POLICY REPORT
DEVELOPMENT AND BUILDING

TO: Vancouver City Council
FROM: Acting General Manager of Planning & Development Services
SUBJECT: CD-1 Rezoning - 5189-5289 Cambie Street

5189-5289 Cambie
PROPOSED CONDITIONS OF APPROVALS

Figure 2: Site Plan

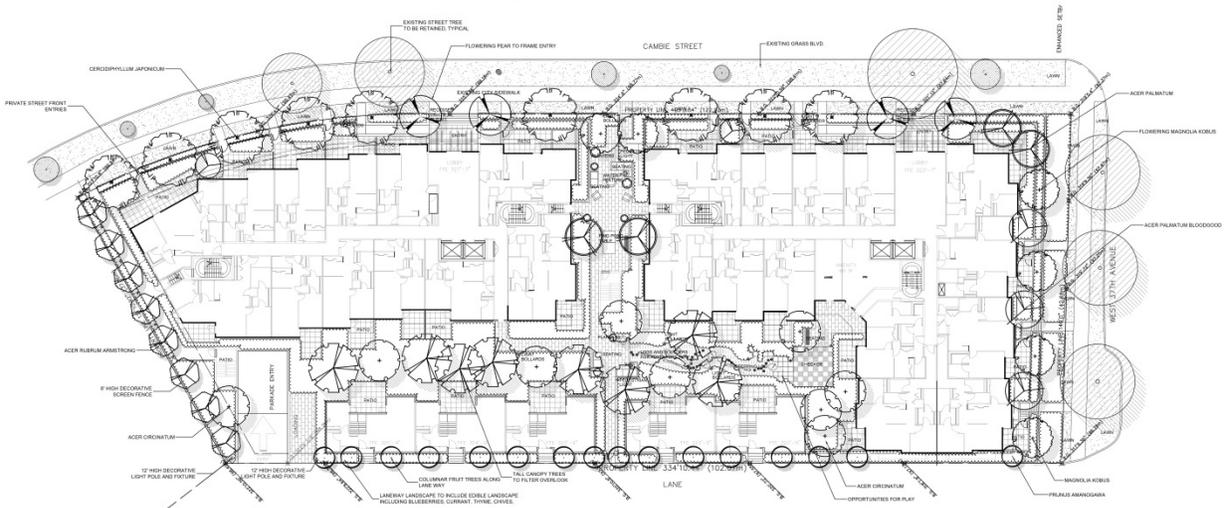
- 3. Design development to improve views through and use of the central courtyard by deleting the parkade exit.

- 4. Design development to reduce overlook impact due to the roof deck at Level 3 of the building return along 37th Avenue.

Note to Applicant: The Class B loading space shown on drawing L2 has no direct access to the buildings and is located at the north end of the site.

- (iv) Relocate the parking entry to provide a minimum 15m separation between the parking ramp for 5101 Cambie Street, See related permit (DE418277).

Note to Applicant: The parkade exit should be covered and may be relocated to a less prominent area.

Note to Applicant: Occupied portions of the roof deck at Level 3 should be setback from the lane elevation with a substantial landscape buffer.
